ADDENDUM NUMBER 2

Dated April 21, 2016

Exchange Club Park
 Frontage Improvements Project
 Mayberry Avenue and Fairview Avenue
 Community of Valle Vista
 Project No. C6-0081

**UNDER SIDEWALK
DRAIN
CAST IN PLACE**

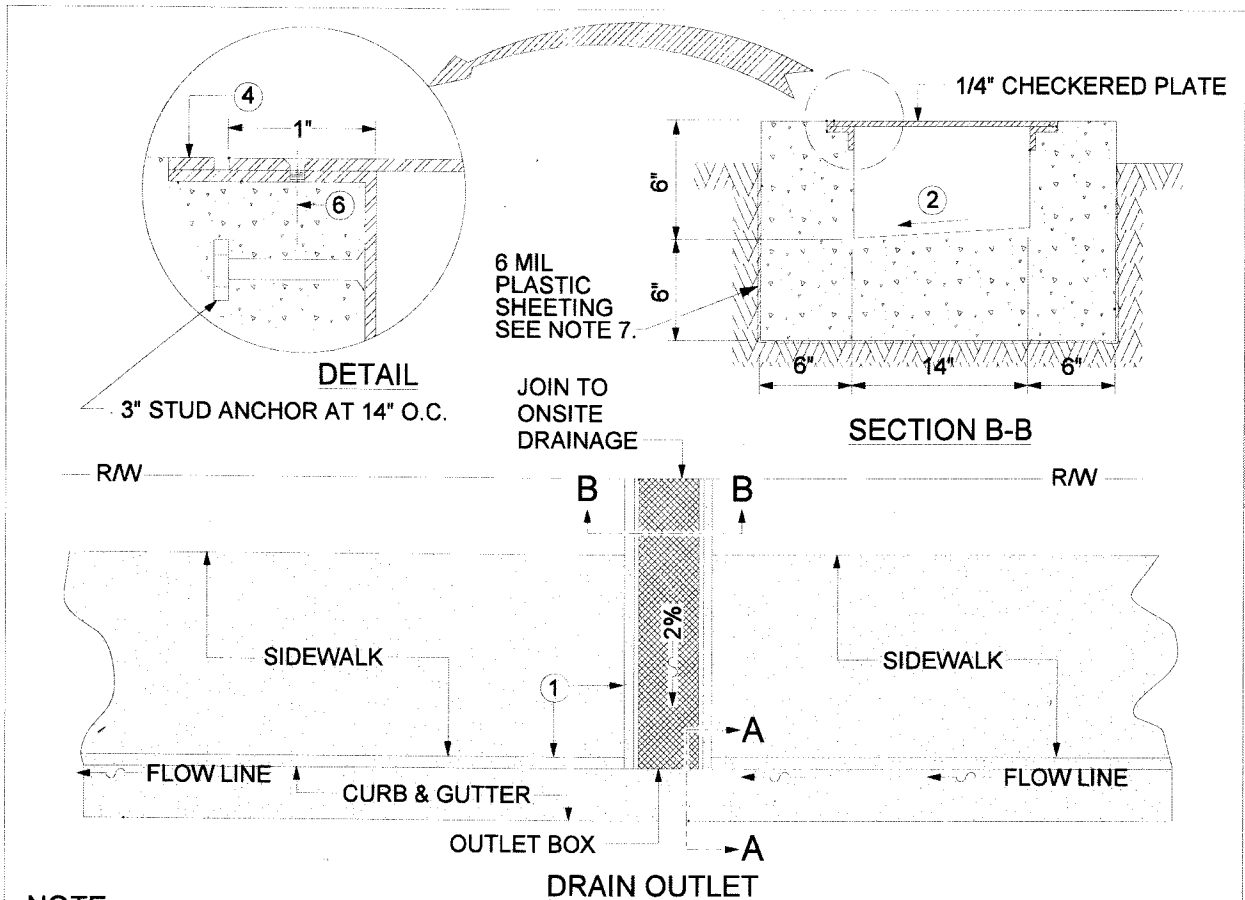
Item 3: Addition of Reference Drawings. Refer to Appendix B, Reference Drawings, of the Special Provisions. The following reference drawings are added by **Attachment "B"** and made part hereby:

- County Std. 309 for Under Sidewalk Drain Cast in Place
